# Intel<sup>®</sup> Pentium<sup>®</sup> III Processor Specification Update

Release Date: October 2004

Document Number: 244453-050

The Pentium<sup>®</sup> III processor may contain design defects or errors known as errata which may cause the product to deviate from published specifications. Current characterized errata are documented in this Specification Update.

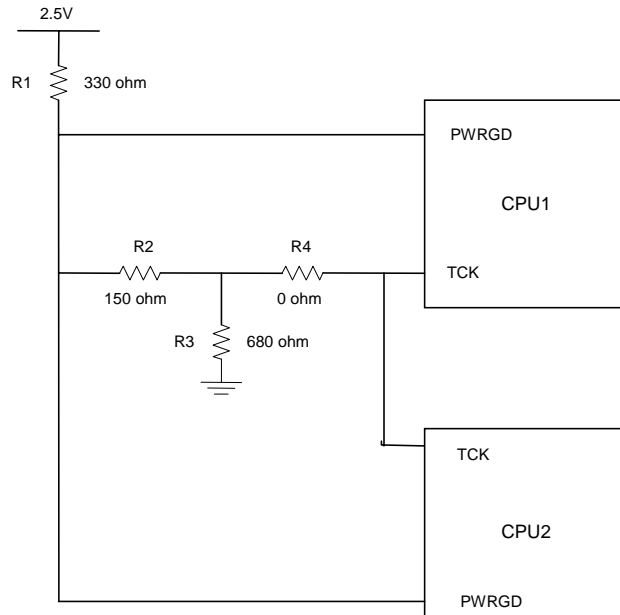
**Problem:** The internal control register bit responsible for operation of the Thermtrip circuit functionality may power up in a non-initialized state. As a result, THERMTRIP# may be incorrectly asserted during de-assertion of RESET# at nominal operating temperatures. When THERMTRIP# is asserted as a result of this erratum, the processor may shut down internally and stop execution but in few cases continue to execute.

**Implication:** This issue can lead to intermittent system power-on boot failures. The occurrence and repeatability of failures is system dependent, however all systems and processors are susceptible to failure. In addition, the processor may fail to stop execution during the event of a valid THERMTRIP# assertion resulting in the potential for permanent processor damage.

**Workaround:** To prevent the risk of power-on boot failures or catastrophic thermal failures, a platform workaround is required. The system must provide a rising edge on the TCK signal during the power-on sequence that meets all of the following requirements:

- Rising edge occurs after Vcc\_core is valid and stable
- Rising edge occurs before or at the de-assertion of RESET#
- Rising edge occurs after all Vref input signals are at valid voltage levels
- TCK input meets the Vih min and max spec as mentioned in EMTS
